UNITED STATES DEPARTMENT OF COMMERCE United States Patent and Trademark Office Address: COMMISSIONER FOR PATENTS P.O. Box 1450 Alexandria, Virginia 22313-1450 www.uspto.gov

| APPLICATION NO. | FILING DATE | FIRST NAMED INVENTOR | ATTORNEY DOCKET NO. | CONFIRMATION NO. |
|------------------------------|--------------------------|----------------------|---------------------|------------------|
| 10/792,322 | 03/03/2004 | Jea-Hyuck Lee | 5000-1-542 | 4368 |

| | | Арр | lication No. | Applicant(s) | Applicant(s) | | | |
|---|---|--|---|---|---------------|--|--|--|
| Office Action Summary | | | miner | Art Unit | | | | |

DETAILED ACTION

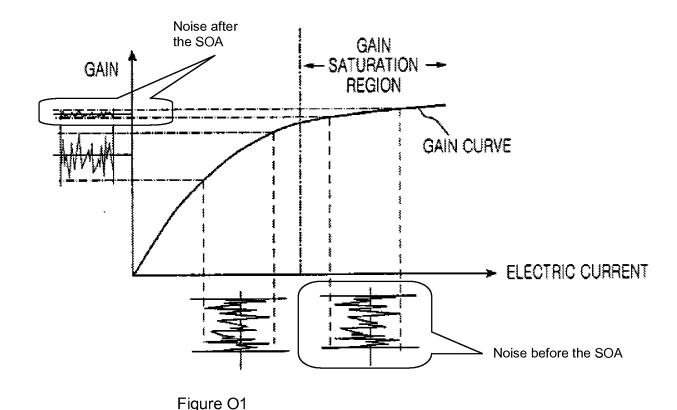
Examiner's response – What is claimed are: a semiconductor optical amplifier (SOA) configured to amplify the optical signal in a gain saturation state and the mode partition noise of the optical signal, wherein <u>said noise intensity</u> is increased and rendered substantially constant. That is the claim compares the noise before the SOA with the noise after the SOA. The claim never compare the noise of the claimed invention with the noise of "conventional Fabry-Perot laser's noise". See Figure 7 of the applicant (or the following Figure O1):

Figure O1 shows that comparison with the noise before the SOA, the noise intensity after the SOA is reduced.

Also, the Figure O1 (or the Figure 7 of the applicant) shows that the noise intensity is reduced after the SOA which is in gain saturation state.

The original specification discloses that the SOA is used to minimize the relative intensity noise, so to also reduce the mode partition noise (Figures 7 and 8). And, "an optical signal, into which a plurality of mode-locked channels are multiplexed, is amplified by an SOA in a gain saturation state, so that mode partition noise due to a partition of each channel is compensated. As a result, loss of each channel due to the mode partition noise is compensated, yielding an improvement in transmission speed and transmission distance" (page 12, line 21 to page 13 line 3). Therefore, the mode partition noise after the SOA operated in gain saturation state is reduced, not increased.
